SERVICE BULLETIN

Number: SB0202

Subject: Deck Lift Rod on Z-34 Riders

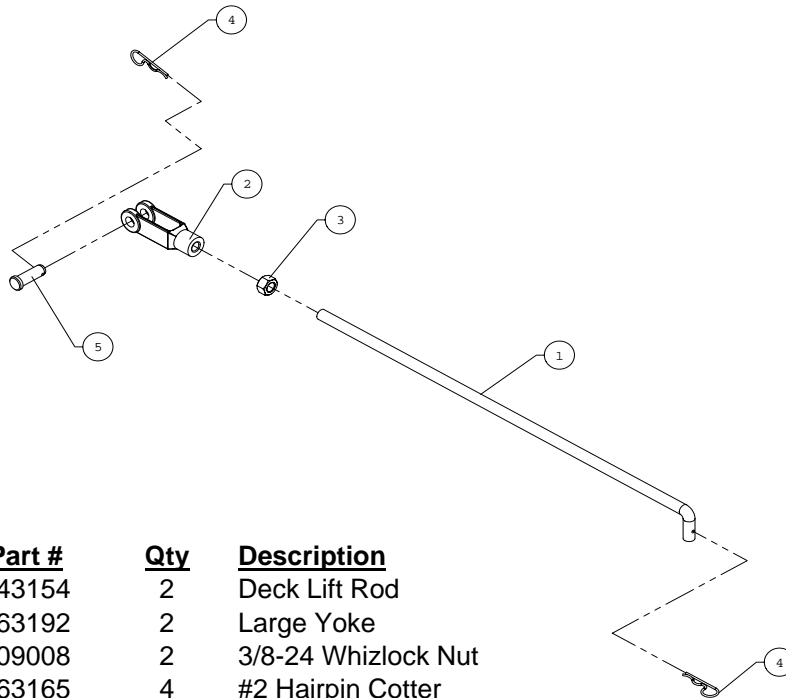
In a continued effort to improve the ease of deck adjustment on the Z-34, there has been a change made to the Deck Lift Rod.

Please make the following changes to the Z-34 Parts Manual in the Main Frame Assembly section, figure 1 of 2.

Item # 55 should be changed to part # 343154. In addition to this change, you will need to also add the following parts:

<u>Item</u>	<u>Part #</u>	<u>Qty</u>	<u>Description</u>
1	343154	2	Deck Lift Rod
2	363192	2	Large Yoke
3	109008	2	3/8-24 Whizlock Nut
4	363165	4	#2 Hairpin Cotter
5	363196	2	Large Clevis Pin

Objective: By adjusting the length of the Deck Lift Rod, you can change the side to side level of the deck and also set the front to back pitch.
